# TECHNICAL ADVISORY REPORT

IN SUPPORT OF THE JOINT LETTER OF INTENT  
FOR TATA STEEL NETHERLANDS

Date of publication: 29 September 2025

Figure 9. Predicted CO<sub>2</sub> emissions per (sub)project [6]

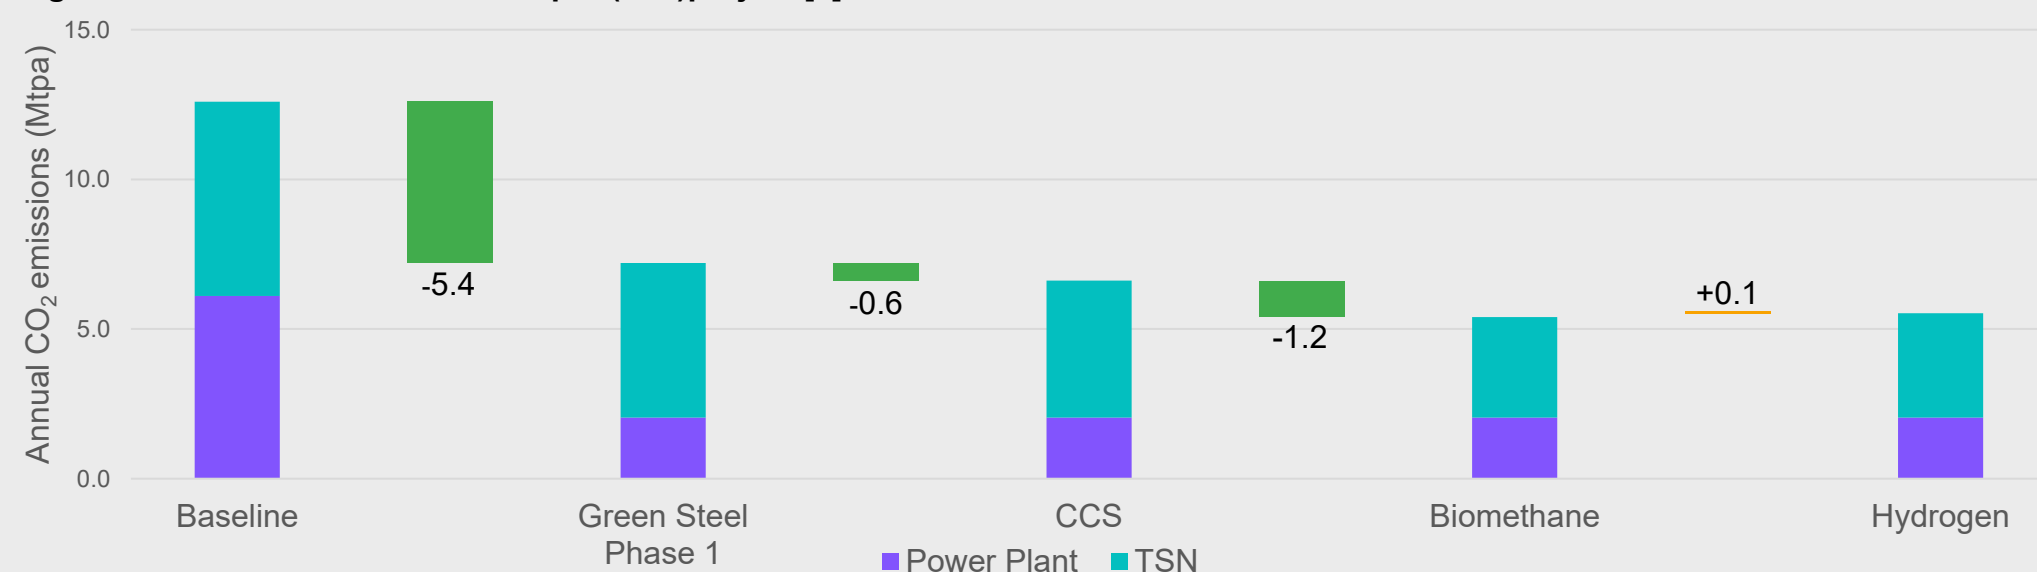
To calculate CO<sub>2</sub> emissions, TSN uses its in-house Carbon (reduction) Selection Model (CSM) which is based on carbon mass-balance principles and historical data for the existing assets. The material flows for the new assets (DRP-EAF) are sourced from databooks provided by the Original Equipment Manufacturers (OEMs). Overall, the methodology is considered appropriate and in line with industrial best practice. However, some uncertainties are identified:

- Only the major assets onsite are included.
- Minor carbon flows (e.g. scrap and steel products) are excluded.
- Only CO<sub>2</sub> is included; other greenhouse gasses are omitted.
- The coking time of CGP1 will increase once Green Steel Phase 1 is implemented. This operational change can impact the material balance over CGP1, but is not completely reflected in the calculations.
- Some consumption factors in the CSM differ from source documents.

A margin of 0.6 Mtpa has been agreed upon in the JLoI. This margin is considered sufficient to allow for any of the above-mentioned uncertainties to materialise. Therefore, it is likely the stated CO<sub>2</sub> objectives in the JLoI can be achieved with Green Steel Phase 1. The scope of this review only covers scope 1 emissions, scope 2 and 3 emissions are specifically not part of this review.

Figure 11. TSN's predicted PM<sub>10</sub> immission contribution reductions in WaZ [6]

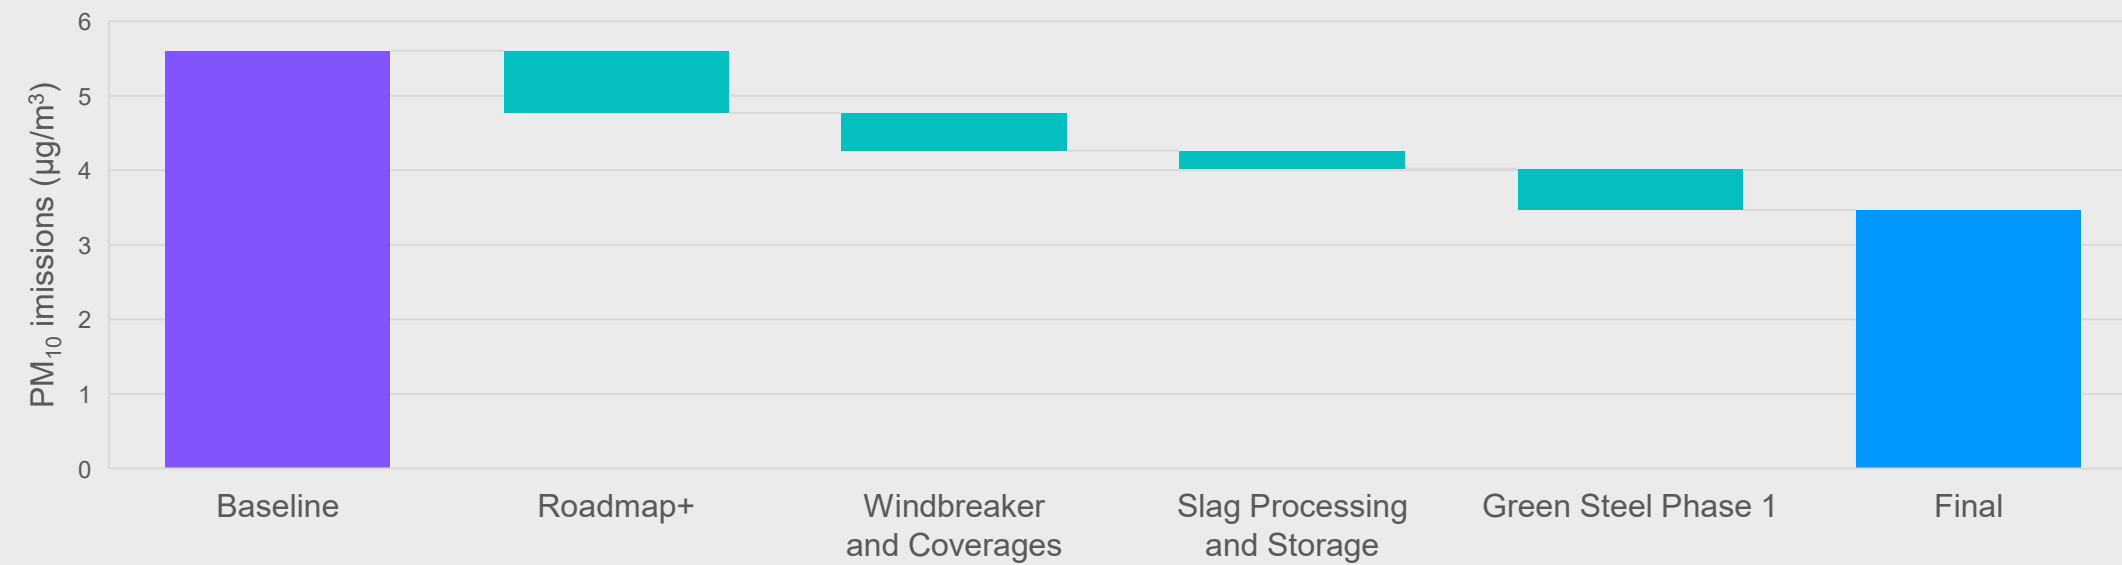
TSN estimates its 2019 baseline immission contribution in WaZ at 5.6 µg/m<sup>3</sup>, including chain partners Harsco and PHY. To meet the 35% target, a reduction of approximately 2.0 µg/m<sup>3</sup> is required (Figure 11). TSN predicts a 38% reduction (2.1 µg/m<sup>3</sup>) through combined measures (reduction percentages and totals may differ due to rounding):

The PM<sub>10</sub> immissions have been calculated using TSN's emissions data and dispersion industry-standard dispersion modelling software. While this approach aligns with industry best practice, and dispersion modelling is the appropriate tool for predicting future immissions, this introduces additional uncertainty such as not being able to predict future meteorological conditions and how the model calculates pollutant dispersion. Independent baseline immissions estimates by RIVM, derived from alternative modelling and monitoring data analyses, range from 4.6 to 7.4 µg/m<sup>3</sup>. TSN's baseline immission estimate of 5.6 µg/m<sup>3</sup> falls within this range. However, the spread of values highlight the inherent uncertainty in immission modelling.

**Figure 12. PM<sub>10</sub> immission reduction in WaZ from the Windbreaker and Coverages [6]**

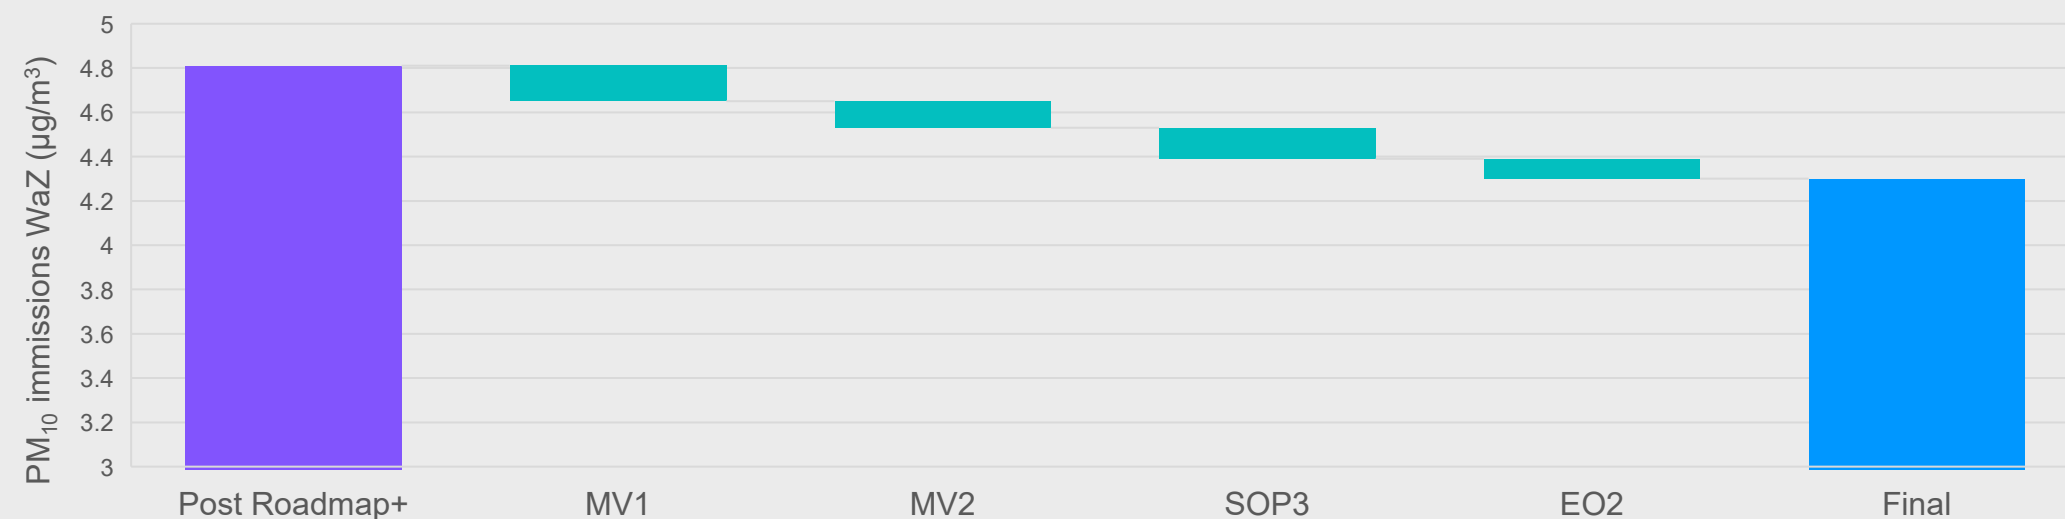
Measures include a windbreaker at MV1 and coverages at MV2, EO2, and SOP3. These are predicted to reduce PM<sub>10</sub> immissions by ~0.5 µg/m<sup>3</sup> (~9%) (see Figure 12). As detailed on page 15, TSN's calculations have used emission factors from national guidance and dispersion modelling by an independent consultant. Reduction factors applied (90% for full coverages and 50% for the windbreaker) are supported by published literature and wind simulation data. This methodology aligns with industry best practice, however the predicted reductions are subject to uncertainty due to the cumulative effects of:

Monitoring will provide transparency, verify performance, and allow adjustments if actual reductions differ from predictions.

Figure 14. Long-term average noise levels [15]

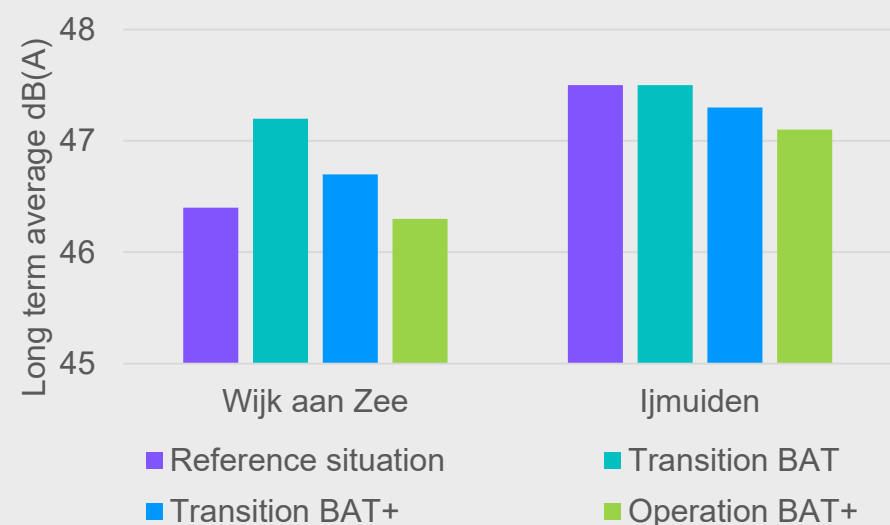
The assessment predicts that average noise levels in WaZ and IJmuiden will decrease slightly after implementation of the Green Steel Phase 1 (Figure 14). The reductions are less than 1 dB, which is generally considered imperceptible under normal conditions (a 1 dB change is the smallest detectable in controlled environments, while 3 dB is readily noticeable). Although these changes may not be perceptible individually, they are expected to contribute to an overall improvement in ambient noise perception. It should be noted that this study only considers the Green Steel Phase 1, Additional Environmental and Health Measures were not included.

Noise nuisance is mainly attributed to peak and tonal noises, however TSN has not been able to identify the sources of the complaints. As such, additional monitoring is proposed as part of the Additional Environmental and Health Measures to further understand peak and tonal noises. Subsequently, TSN will be able to take measures to reduce nuisance. Average noise levels have been assessed and are not expected to change noticeably after implementation of the Green Steel Phase 1. The approach to the assessment is robust and aligns with industry standards.

Figure 18. Two Water Granulation Concepts [16]

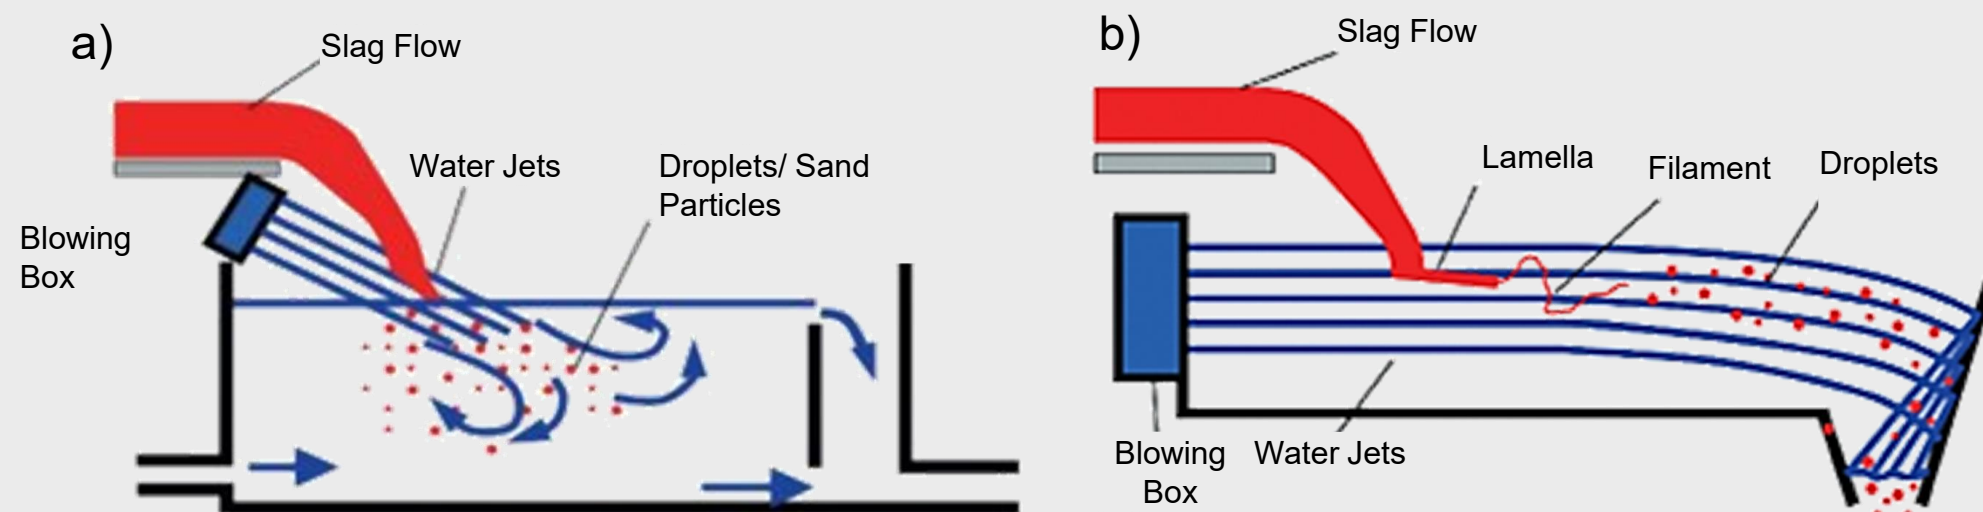
TSN has selected water granulation as the preferred processing method after evaluating alternatives. This process rapidly cools molten slag with water jets to form glass-like granules (Figure 18). TSN currently uses water granulation for blast furnace slag, which is widely used as SCM.

Future regulatory changes on heavy metals could significantly impact the viability of slag applications. TSN has acknowledged that stricter limits on chromium and vanadium could pose a major challenge.

TSN's slag processing and application plan is in early stages of development. The current plan relies on a technology and application pathway that is not yet proven at the required scale. Significant challenges and uncertainties remain regarding technical feasibility, certification, and environmental compliance. A clear and detailed development roadmap, supported by OEM commitments and independent testing, will be essential to reduce these uncertainties. Due to the uncertainties with water granulation, TSN is engineering quench cooling as fallback option, which is considered a more proven technology, although challenges with SCM application remain.

Figure 19. Phase-by-Phase and Total CapEx for Green Steel Phase 1 [6]

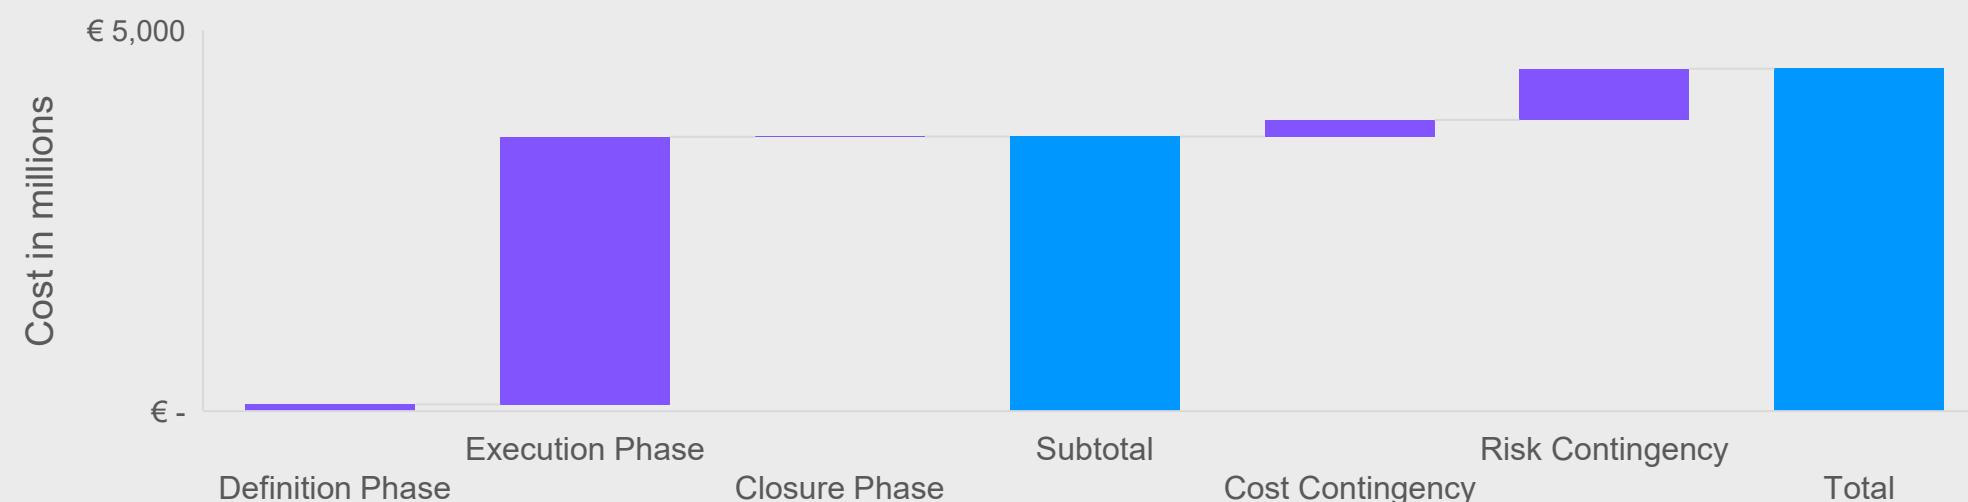
TSN's total CapEx allowance for Green Steel Phase 1 is approximately €3.6 billion, excluding contingency and risk provisions. When these are included, the total rises to around €4.5 billion. The estimate is structured across three phases (see Figure 19):

- **Cost contingency:** TSN has included 6%, which is considered low given the level of definition. A contingency of ~10% would be more appropriate.
- **Risk contingency:** Currently 19%, based on an outdated risk assessment, but considered broadly reasonable.

Figure 20. CapEx estimate Windbreaker and Coverages [6]

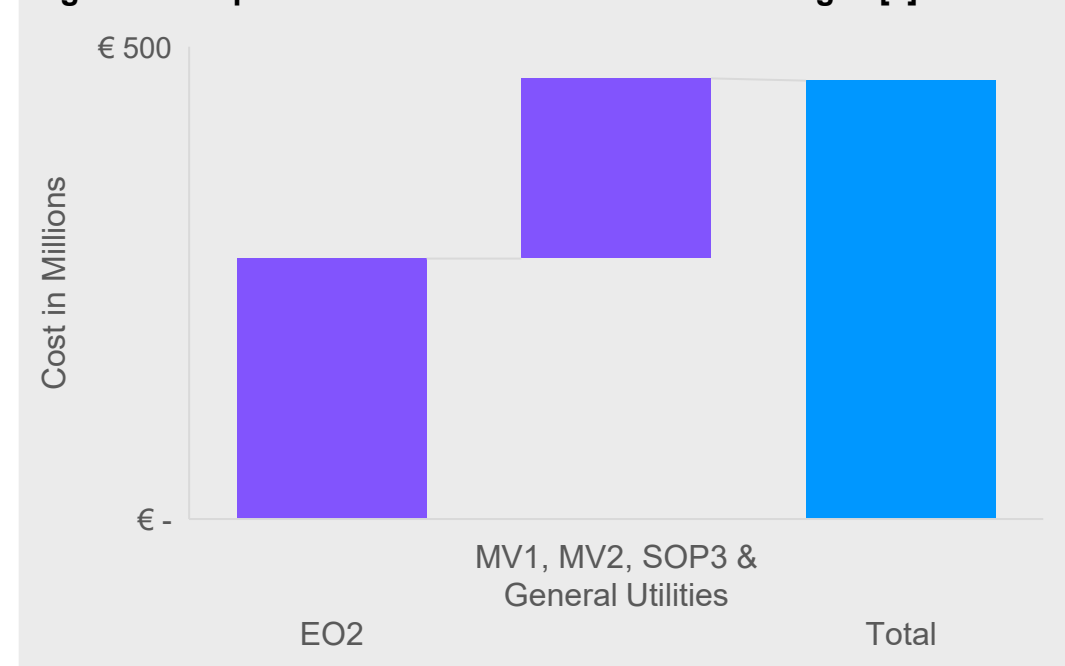
TSN's total CapEx allowance for the Windbreaker and Coverages project is approximately €465 million, divided across four main storage areas (EO2, MV1, MV2, SOP3) and General Utilities (Figure 20). The estimate is structured as follows:

EO2 accounts for 60% of total project costs (~€275 million) and is at FEL1/2 maturity. Current contingency is 17%, which is low given the early stage and identified issues. A contingency of 25% is considered more appropriate. As this estimate accounts for 60% of the total programme costs, this significantly affects the total integrity of the cost estimate.

Figure 21. Accuracy of the CapEx estimates per asset [6]

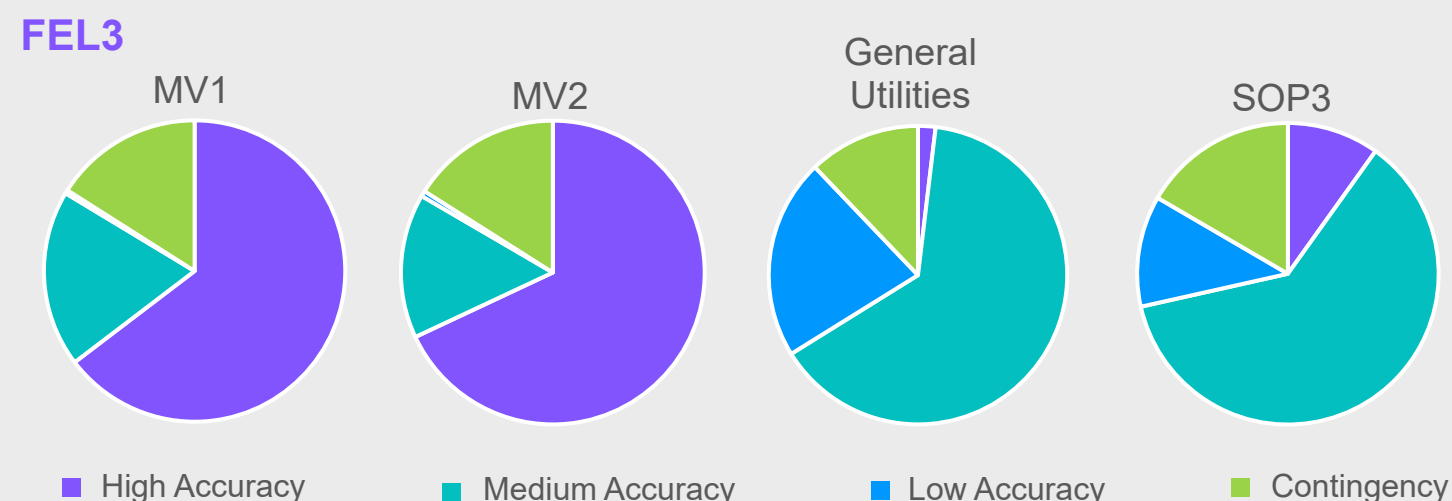
- **MV1 and MV2:** Data accuracy is medium to high (Figure 21), supported by budget quotes and benchmarks.
- **SOP3 and General Utilities:** Data has a lower accuracy, with limited breakdowns and reliance on in-house estimates. No detailed breakdown was provided for project management office costs, which introduces uncertainty.
- **Contingency:** for general utilities is lower than for other areas, despite higher uncertainty.

Figure 22. Total CapEx Slag Processing and Storage [6]

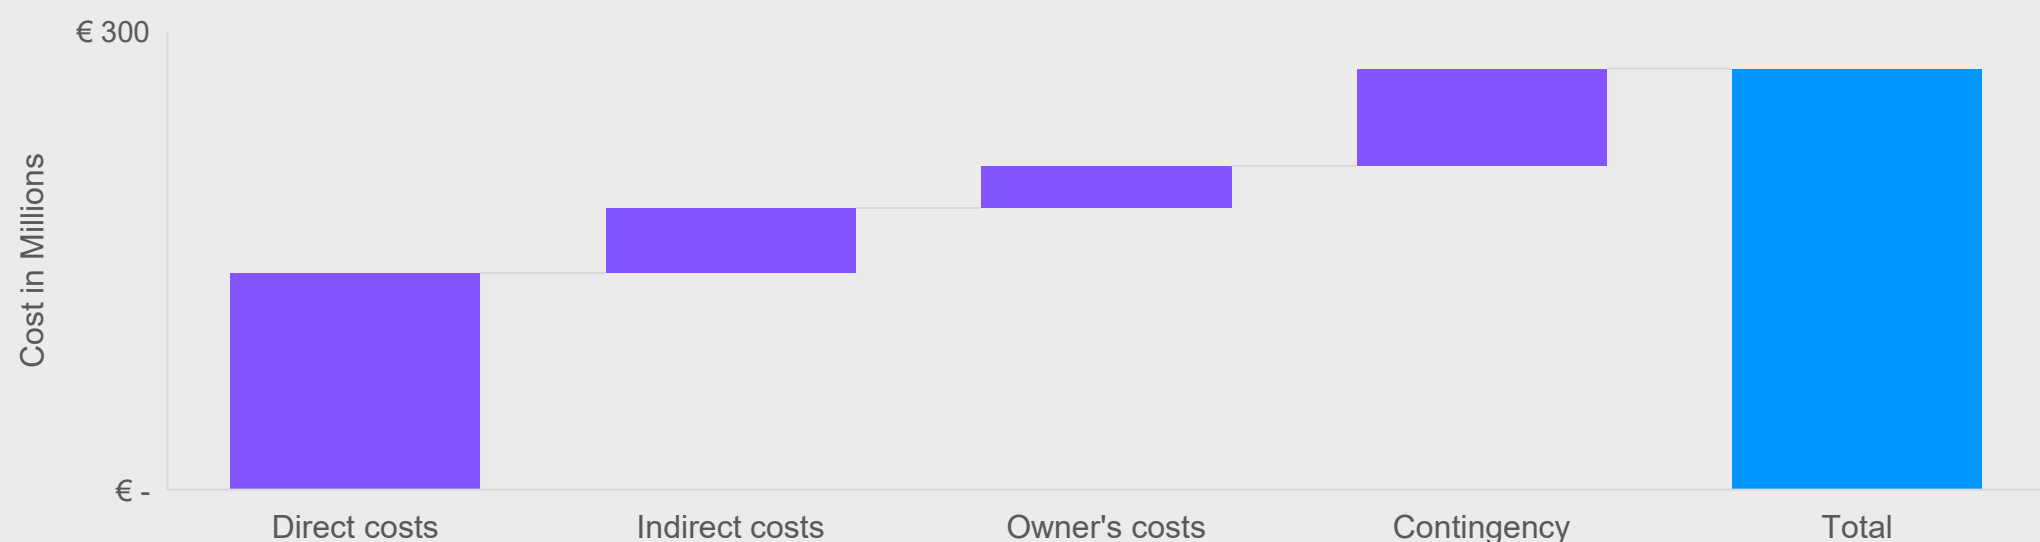
- **Direct cost:** Estimated at approximately €145 million, includes buildings and gas cleaning, windbreaker PHY, metal recovery plant and humidification and sieve installation.
- **Indirect Costs:** ~30% uplift on direct costs.
- **Owner's Costs:** ~15% uplift on indirect costs.
- **Contingency:** ~30% uplift on total costs.

A contingency of 30% is applied to the total estimate. This is in line with expectations for FEL1 maturity.
